**INSPECTION, TESTING, AND MAINTENANCE OF FIRE AND LIFE SAFETY SYSTEMS
AT THE YOUTH SERVICES CENTER AND
NEW BEGINNINGS YOUTH DEVELOPMENT CENTER**

Report 2025 – 1

OFFICE OF INDEPENDENT JUVENILE JUSTICE FACILITIES OVERSIGHT

2.0 Existing Fire Alarm System

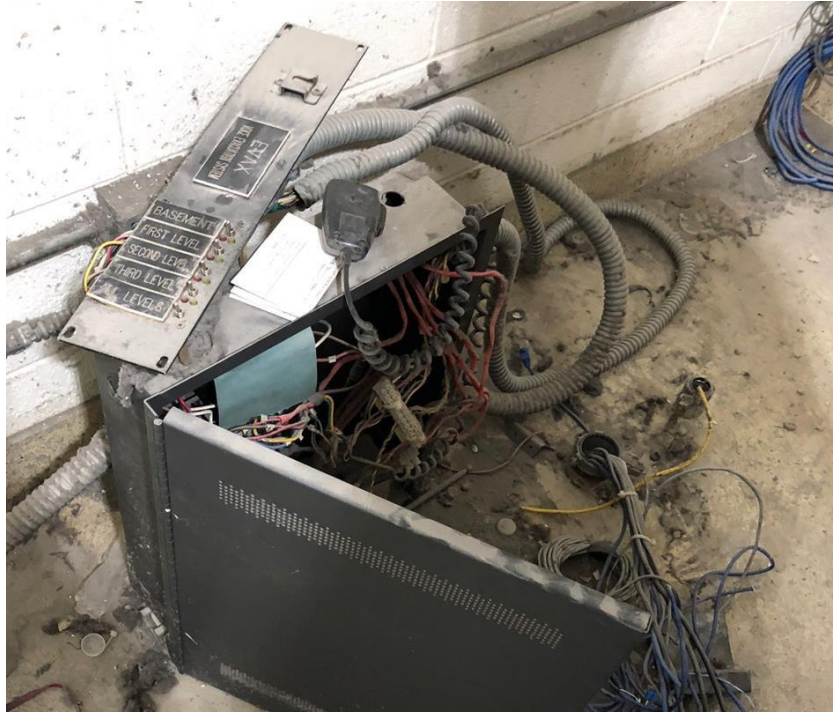
The existing fire alarm system is a voice evacuation Siemens MXL system presumably installed when the building was constructed circa 2004. The Siemens MXL was originally introduced to the market in the 1990’s. The manufacturer offered this type of system through October 1, 2013. System parts and components were provided for a five year period from 2013 until 2018. MXL detectors and devices were available for a ten year period from 2013 through 2020. The system is no longer officially supported by Siemens and replacement parts are no longer manufactured.

The fire alarm system at YSC consists of a main fire alarm control unit (FACU) located in the Central Control Room 1102, which is currently under construction.¹ Initiation of alarm is accomplished via initiating devices such as: smoke detectors, manual pull stations, duct smoke detectors, sprinkler water flow switches, etc. Notification is accomplished throughout the facility via strobes and fire alarm speakers. Upon alarm, the speakers emit a temporal-3 alert tone, followed by a pre-recorded voice message.

Recommendation 1: Replace the Siemens MXL system at YSC with a new system. A completely new system, including a non-Siemens brand fire alarm system, could be installed, followed by demolition of the existing fire alarm system. Alternatively, the existing Siemens MXL panel and initiating devices could be “migrated” to newer versions using components of the existing system a gradual, phased-in approach. This would require using the same brand system that DYRS currently uses.³ The main steps for the Siemens migration to occur are:
